From: Paul Nolis
Sent: Wednesday, October 2, 2024 7:49 AM
To: Clerks Richmondhill <clerks@richmondhill.ca>
Cc: giuliano.lamoglie@ricvmondhill.ca; Carol Davidson <carol.davidson@richmondhill.ca>; David West <david.west@richmondhill.ca>; Emmerson, Wayne <Wayne.Emmerson@york.ca>
Subject: Fwd: opa-24-0002 and zbla-24-0003

Re: City files : OPA -24-0002 and ZBLA-24-0003

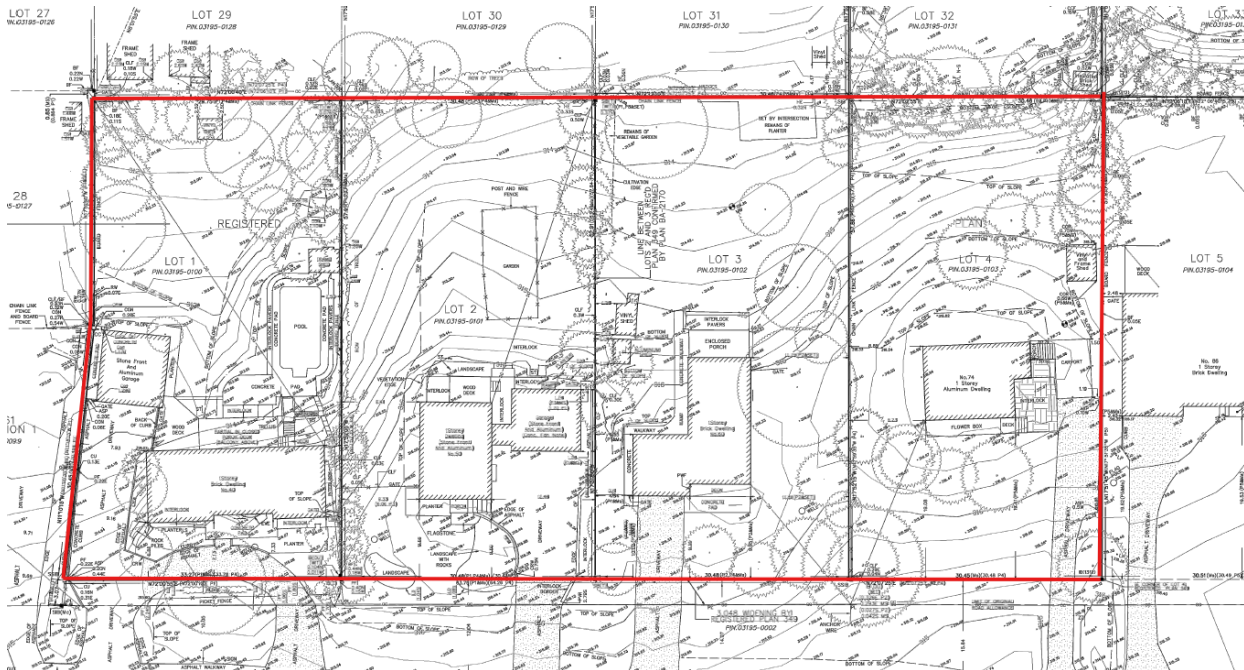
4) The development appears to have underground parking. Will any portion of the underground parking be visible above ground? If so, how much visibility will there be? Please explain with detail how this underground parking concept will actually be in use?

Yes, there is proposed to be 1 level of underground parking.

Based on the section drawings submitted by the applicant, portions of the parking garage will be partially above grade. I have attached the section drawings for your reference.

The underground parking garage is provided beneath the residential units and consists of 108 spaces (1 space per unit). Entrance to the underground parking garage is provided at two access points off the private driveway.

In terms of other parking areas, a limited number of visitor and accessible parking spaces are provided outside of this parking garage at grade near the entrance.
